Please be advised that Township of Puslinch Council, at its special meeting held on May 11, 2022, considered the City of Guelph Official Plan Amendment No. 79 (Clair-Maltby Secondary Plan Amendment) that is being considered by City of Guelph Council for decision at the May 16, 2022 Council meeting.

REPORT ADM-2022-027

SUBJECT: City of Guelph Official Plan Amendment No. 79 (Clair-Maltby Secondary Plan Amendment)

PLANNING REPORT for the TOWNSHIP OF PUSLINCH

**ATTACHMENT 1:
Land Use Plan (Based on the May 2019 Preferred Community Structure)**

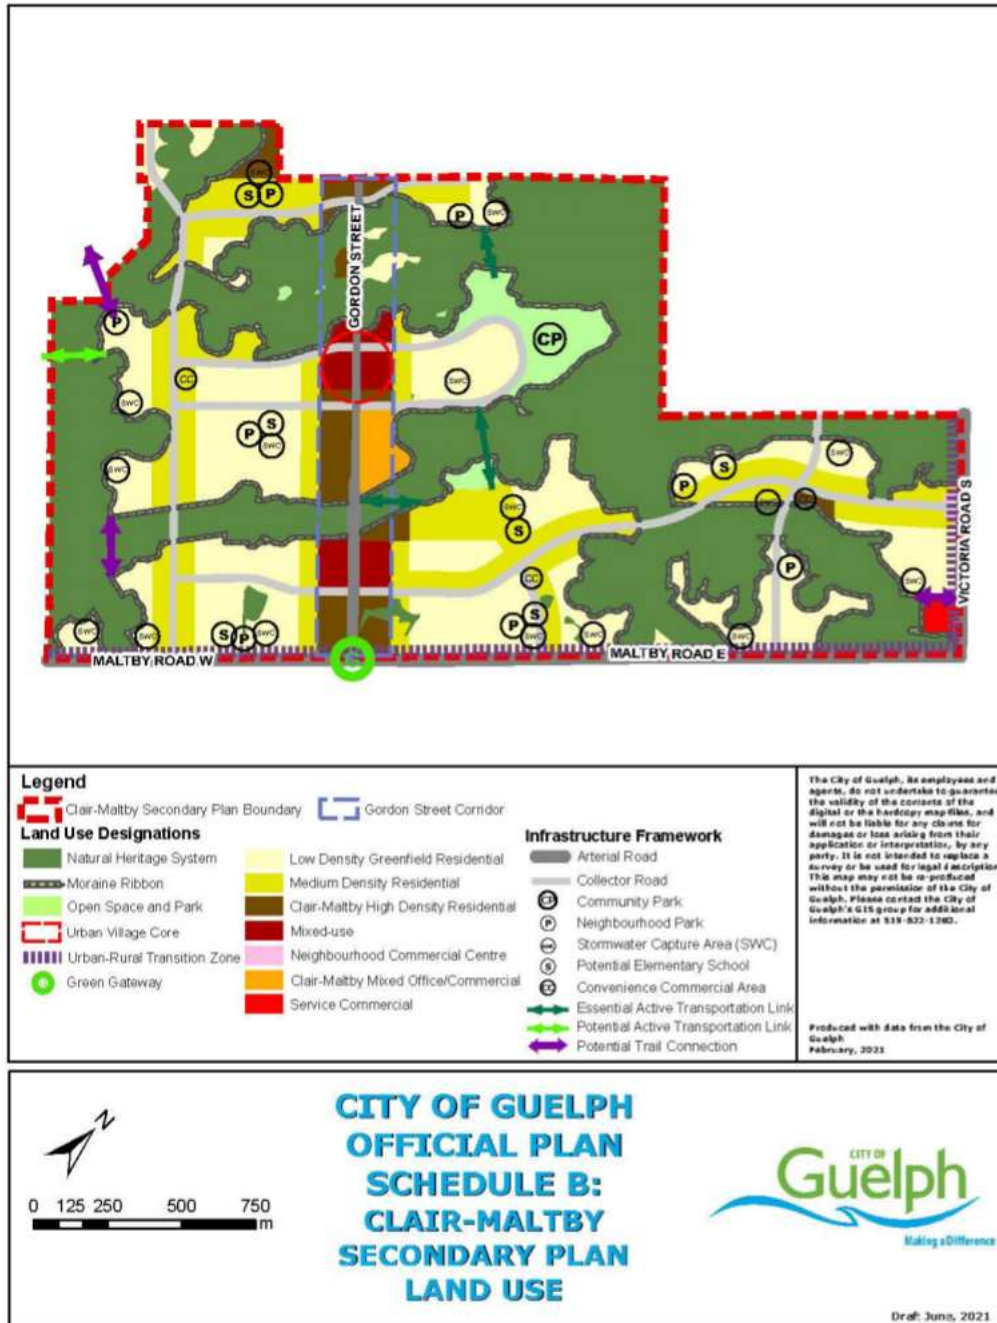
- Urban-Rural Transition
 - Clarification is required in Section 11.3.8.6.11.1 that clearly explains how this 60 m depth is measured so that this cannot be misinterpreted to include the entire right-of-way through future application.

- Section 11.3.8.6.11.4 is requested to provide more detail and direction for a setback standard to ensure a consistent and meaningful application of this policy. The need for increased setbacks is requested to be made a *requirement* which would include details regarding expectations, including a minimum setback distance (preferably 12 metres), and a combination of landscaping and berming.

- There are several collector roads that will connect into Maltby Road and Victoria Road, as shown in the ‘Preferred Community Structure’ within **Attachment 1**.
- Signalization at some of these proposed intersections will be required: two (2) at the proposed collector roads and Maltby Road and one (1) at Victoria Road. This is generally identified in **Attachment 2**, which shows future traffic lanes and controls.
- Gordon Street and Clair Road are intended to be signalized (including the intersections with Maltby and Victoria Road) and widened from 2-4 lanes and urbanized (including sidewalks and
